DOCKET NOS.: 50-329 AND 50-330

APPLICANT : CONSUMERS POWER COMPANY (CPC)

FACILITY : MIDLAND PLANT

SUMMARY OF MEETING HELD OCTOBER 31, 1973 ON QUALITY ASSURANCE

FIELD QUALITY CONTROL
MIDLAND PROJECT

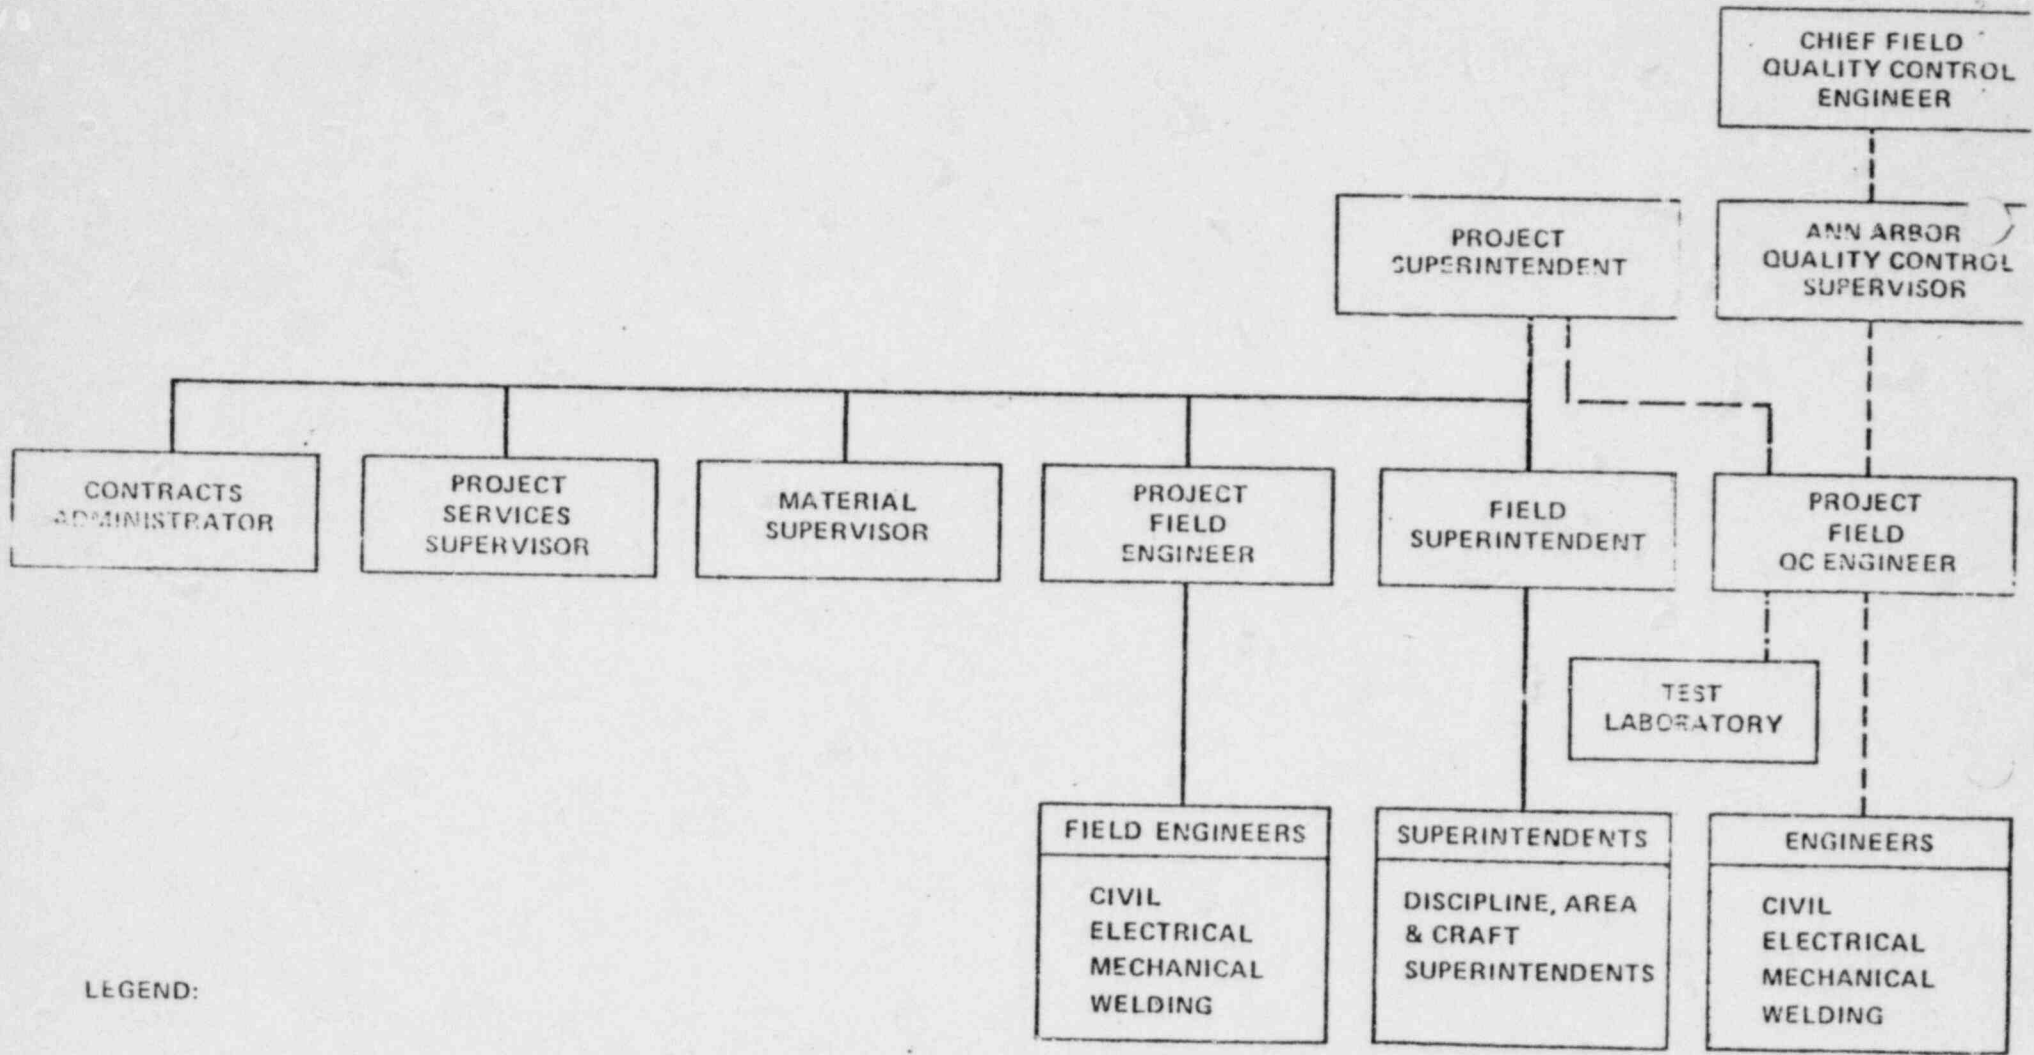
2. Organization Chart 8006180652 G

The chart lacks clarity because there is no solid line to indicate the Project Field Quality Control Engineer's line of primary responsibility. Furthermore, the line connecting the Project Field Quality Control Engineer to the Project Superintendent indicates that the Project Superintendent issues to the Field Quality Control Engineer "directions and instructions concerned with coordination

of day to day project operation." These directions and instructions are not consistent with the independence of the Quality Control Engineer sought by the board.

The applicant assured the staff that their comments would be considered in the final revisions to the Quality Assurance Manuals and the Organization Chart. The revised material is to be submitted to the staff by November 9, 1973.
